Appeal of the Chief Building Official's Decision for a Signage Master Plan Application for 3 wall signs on a portion of the premises

2075 Bayview Avenue

March 1, 2024

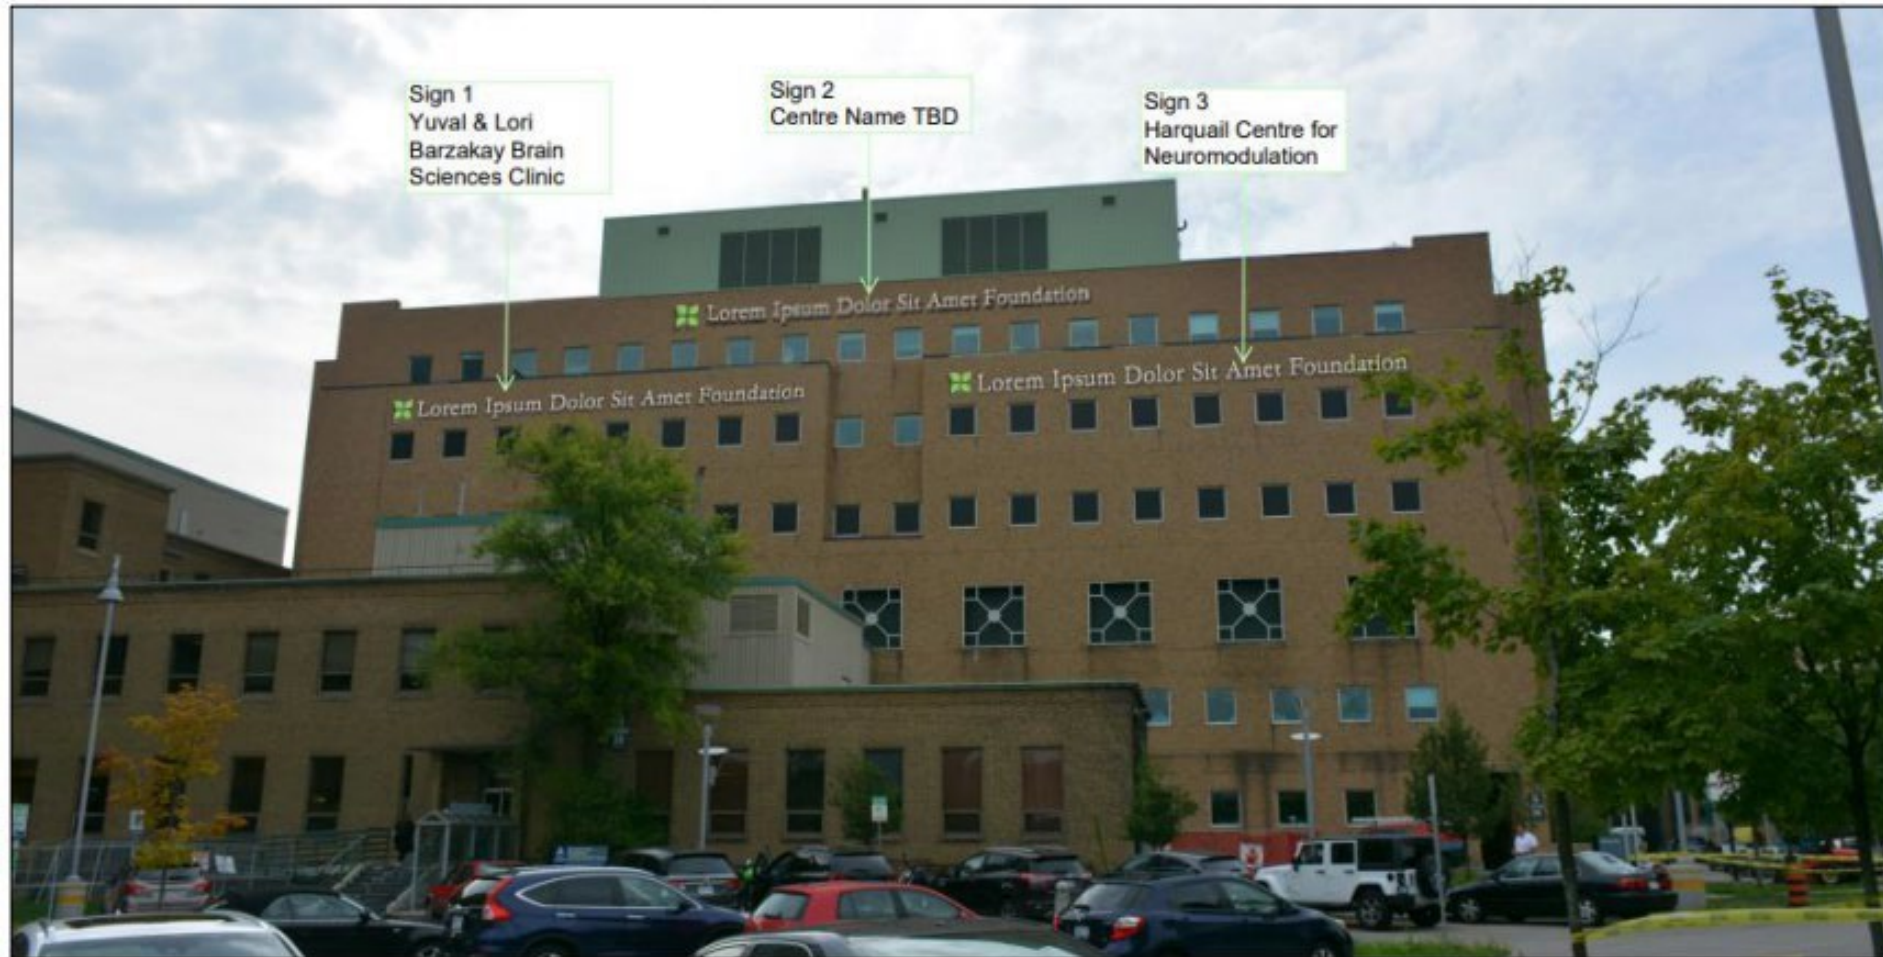
We read with interest the Application for an additional three signs to be affixed on the 5th floor and 6th floor of Sunnybrook Hospital, S Wing, which, if approved, would make for a total of TEN signs on this North facing perspective. Currently, there are already SEVEN signs in place on Sunnybrook's North facing perspective (six on M wing, and 1 on the Odette Centre). According to the by-law 694-21 F (4)(a), signs are only to be erected at the FIRST storey.

The new signs are described as: 1.35m x 24.4m at a height of 23m, with another as 1.35m x 24.4m at a height of 28 m and a third as 1.35mx20.8m at a height of 23m. These are tremendously large proposed signs and, at 5 & 6 stories, are substantially higher than what is permitted. The 23m height of THREE ADDITIONAL illuminated signs will be too bright and too high and will negatively affect neighbours to the north, in whose windows these signs will shine light at all hours.

While we are fortunate to have such a wonderful hospital in our neighbourhood, we cannot support this Application. When the first five signs were approved, homeowners were not in agreement. The lights are bright and shine into the windows and backyards of the homes on the South side of Valleyanna Drive. The signs were approved notwithstanding homeowner disagreement. Neighbours attended personally at City Hall to formally appeal the first sign variance decision and to voice their concerns. Each time, more signs were installed. There are now seven signs. An earlier application in 2021 was also not supported by the Valleyanna Residents.

There has to be a point at which enough is enough. Surely we have long surpassed that point. The seven existing signs currently on the North facing direction do not face the street (Bayview Avenue) and are therefore largely irrelevant to the passing motor traffic. If the three new/proposed signs were to receive more prominent display on the West facing wall instead, that would bring more attention to the signs, and would also leave the homeowners on Valleyanna with more than enough signs with **SEVEN** facing their homes, all which were erected much higher than the permitted first storey elevation. Weirdly, on the west facing walls (the

walls facing Bayview, where all traffic passing and entering the Hospital can see them) there is only ONE sign on each of the M wing and the Odette Centre. None is applied for on the West/Bayview side of the S Wing. Please see attached. SEVEN is more than enough on the north walls facing Valleyanna. Why should Valleyanna be penalized with TEN signs, when there are only two on the West/Bayview facing walls? Or, respectfully, are there enough signs already? Everyone knows where the hospital is, and signage at the first floor can adequately direct visitors.

Again, the hospital is a wonderful neighbour; however, with respect to these signs under Application, please note our **PROFOUND and INTENSE objection** to this Variance Application. The cumulative effect of the bright lights of **TEN** very large signs, all above the allowed first storey elevation, and particularly at the height of 5 & 7 stories, would be detrimental to the homeowners on Valleyanna Drive. Surely we should have a say, or why else is there a process? Why are there by-laws mandating the height (first storey!) of such signs?

Proposed Signs' Location

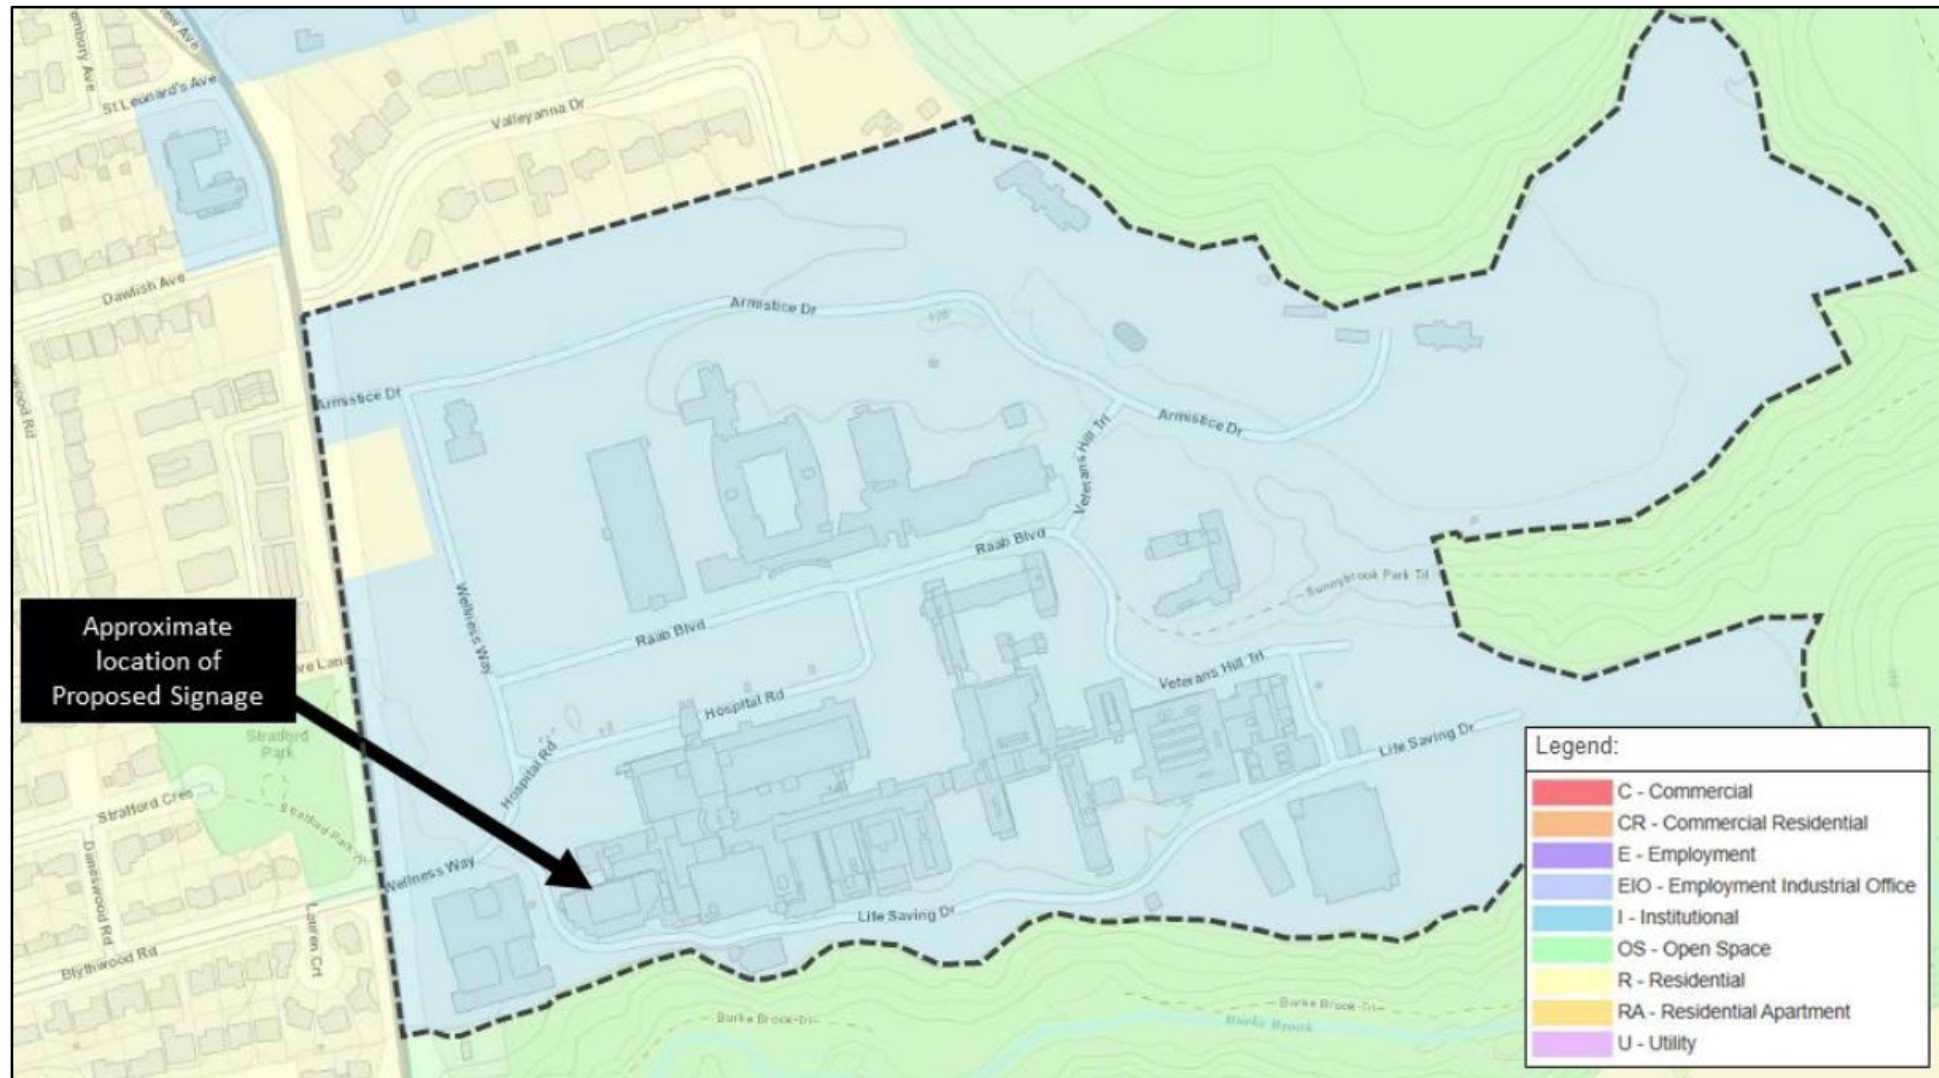
SECTION	REQUIREMENT	PROPOSAL
694-21 F (4)(a)	A wall sign in an Institutional Sign District shall only be erected on the first storey.	Proposed Sign 1 would be erected above the first storey, specifically on the fifth storey
694-21 F (4)(a)	A wall sign in an Institutional Sign District shall only be erected on the first storey.	Proposed Sign 2 would be erected above the first storey, specifically on the fifth storey
694-21 F (4)(a)	A wall sign in an Institutional Sign District shall only be erected on the first storey.	Proposed Sign 3 would be erected above the first storey, specifically on the sixth storey

SECTION Or Condition	REQUIREMENT/Details	PROPOSAL
694-21 F (4)(a)	A wall sign in an Institutional Sign District shall only be erected on the first storey.	All three of the Proposed Signs would be subject to the same variances as in the Proposed Signage Master Plan, but would be subject to the following two conditions
Condition 1	If illuminated, the sign shall not be illuminated between the hours of 11:00 p.m. and 7 a.m.	
Condition 2	If illuminated, the illumination shall not exceed 150 nits during the period between sunset and sunrise.
